SUMMARY OF CHANGES:

THE FOLLOWING IS A SUMMARY CHANGES
BETWEEN MARCH 2019 AND DECEMBER 2019:

KINGS POINT FILING NO. 2
AURORA, COLORADO

CONTEXTUAL SITE PLAN
SUMMARY OF CHANGES

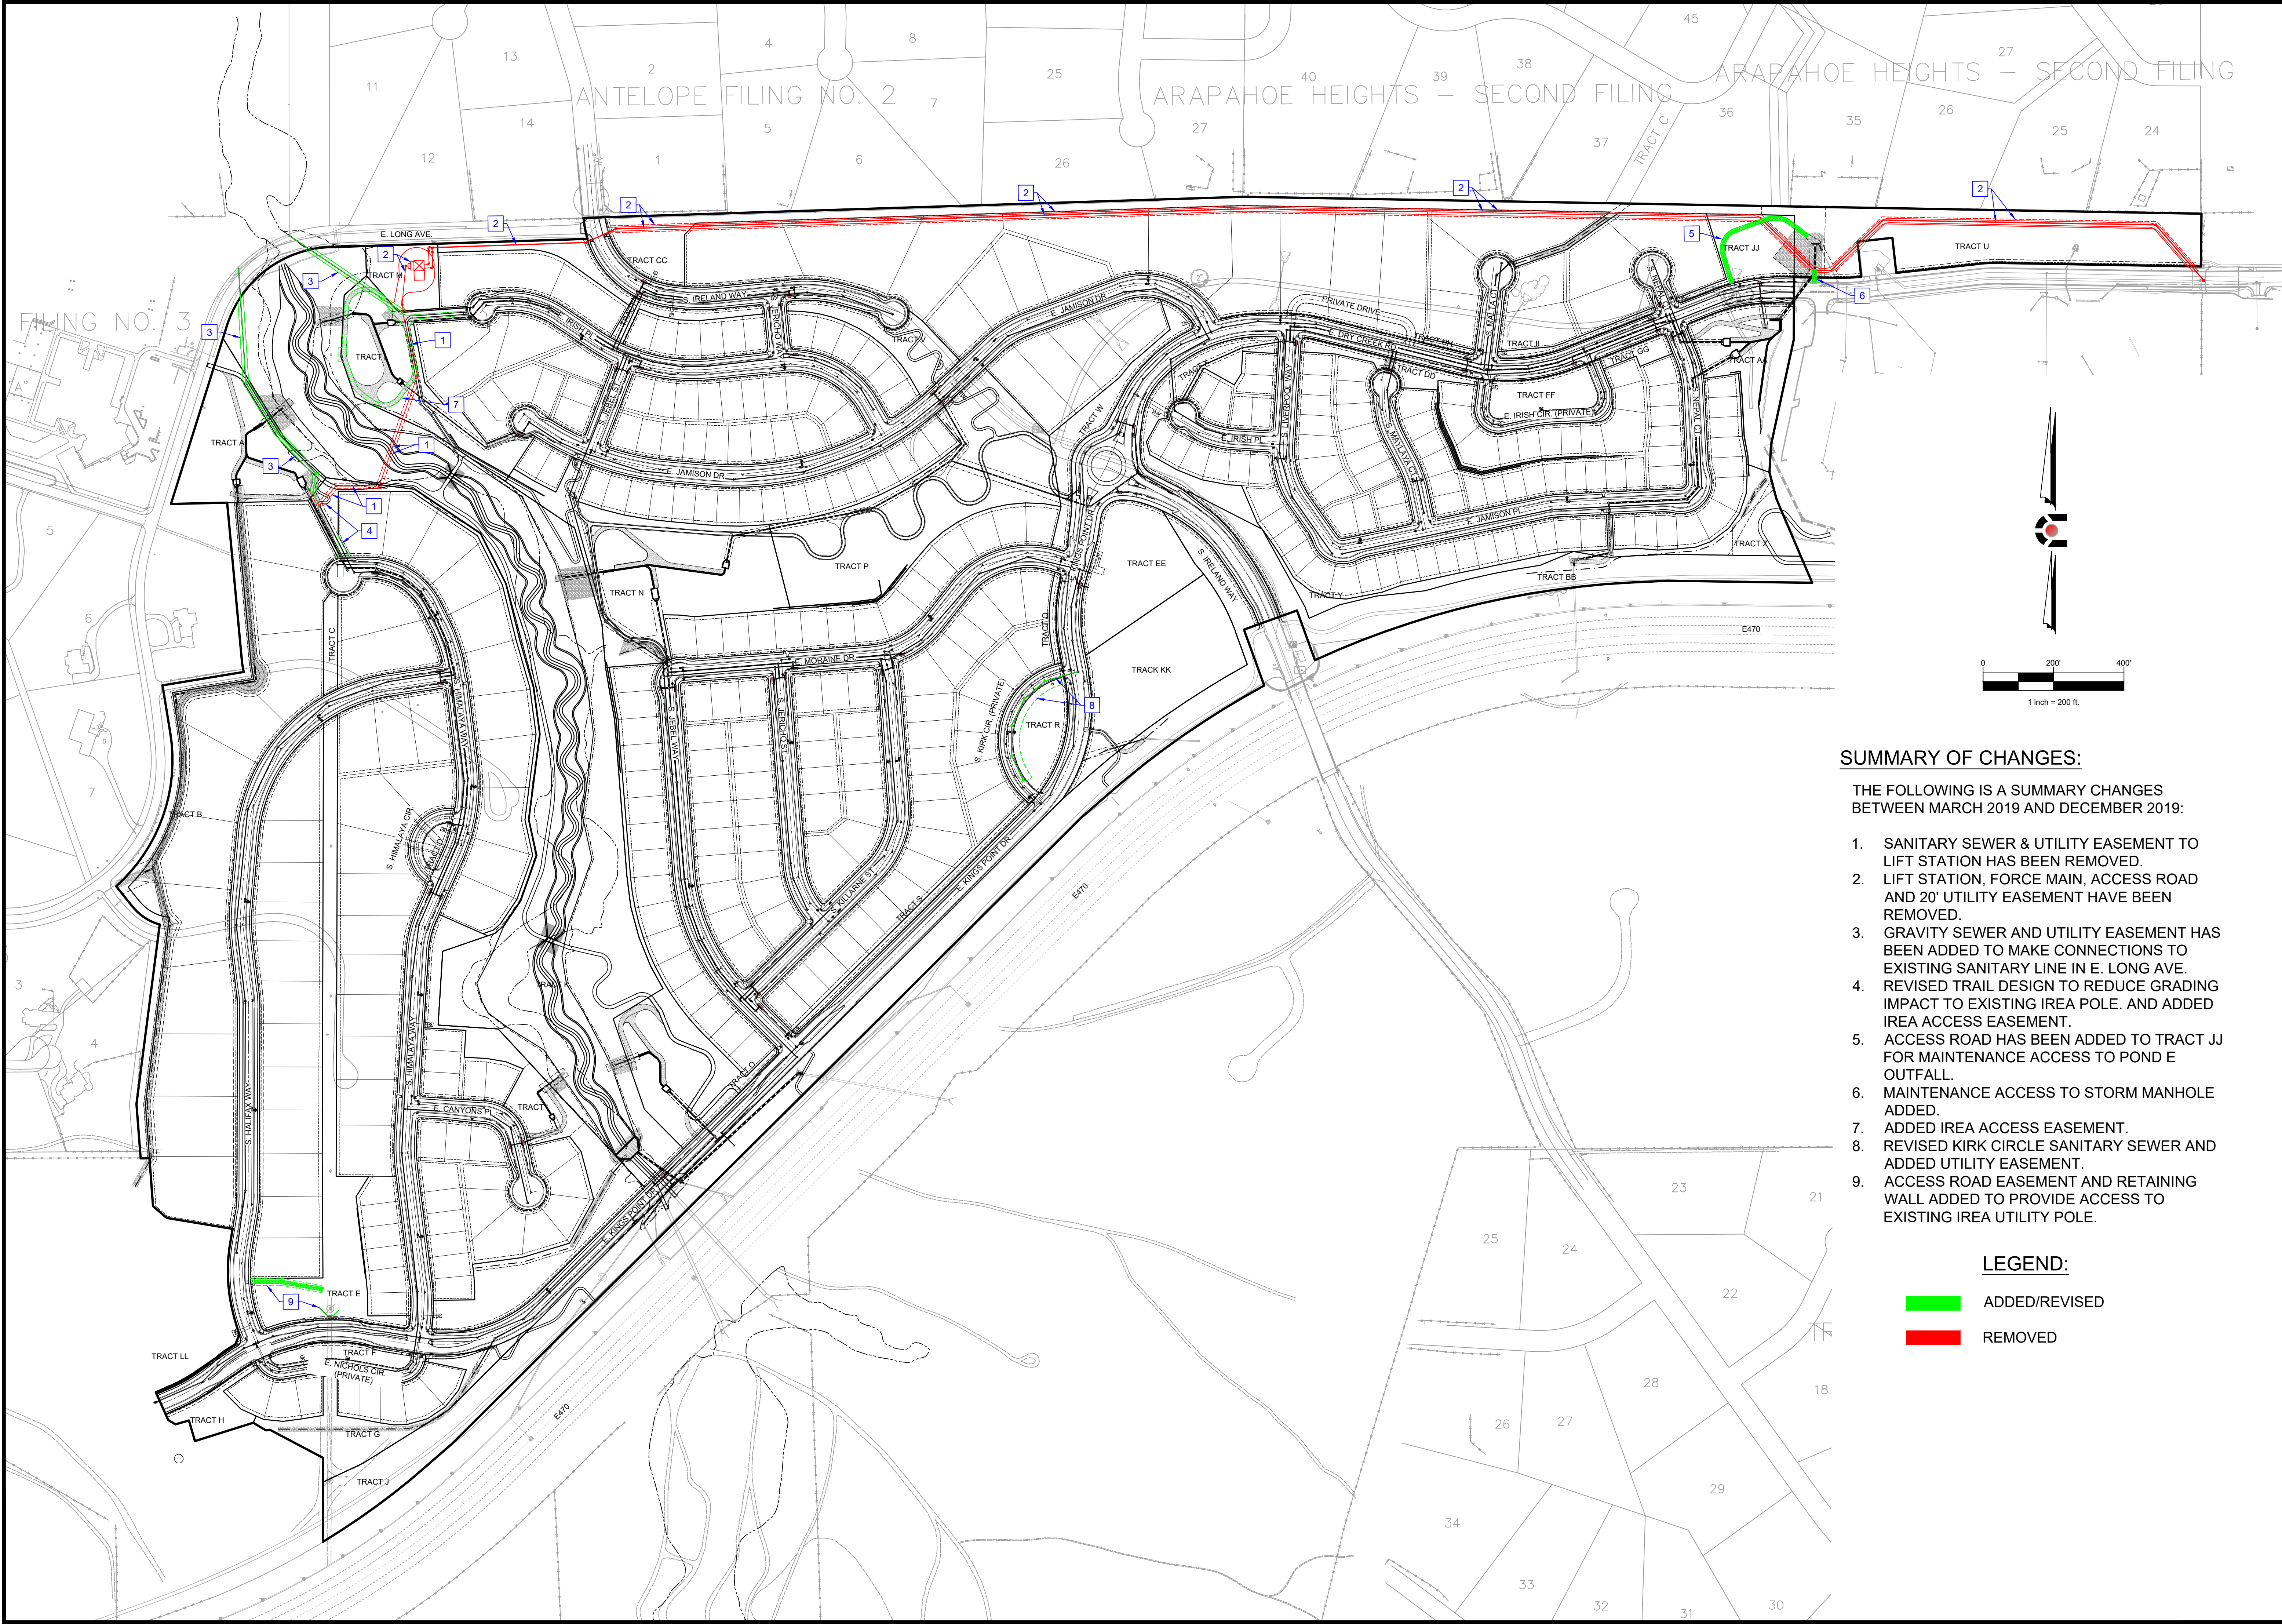
1. SANITARY SEWER & UTILITY EASEMENT TO LIFT STATION HAS BEEN REMOVED.
2. LIFT STATION, FORCE MAIN, ACCESS ROAD AND 20' UTILITY EASEMENT HAVE BEEN REMOVED.
3. GRAVITY SEWER AND UTILITY EASEMENT HAS BEEN ADDED TO MAKE CONNECTIONS TO EXISTING SANITARY LINE IN E. LONG AVE.
4. REVISED TRAIL DESIGN TO REDUCE GRADING IMPACT TO EXISTING IREA POLE. AND ADDED IREA ACCESS EASEMENT.
5. ACCESS ROAD HAS BEEN ADDED TO TRACT JJ FOR MAINTENANCE ACCESS TO POND E OUTFALL.
6. MAINTENANCE ACCESS TO STORM MANHOLE ADDED.
7. ADDED IREA ACCESS EASEMENT.
8. REVISED KIRK CIRCLE SANITARY SEWER AND ADDED UTILITY EASEMENT.
9. ACCESS ROAD EASEMENT AND RETAINING WALL ADDED TO PROVIDE ACCESS TO EXISTING IREA UTILITY POLE.
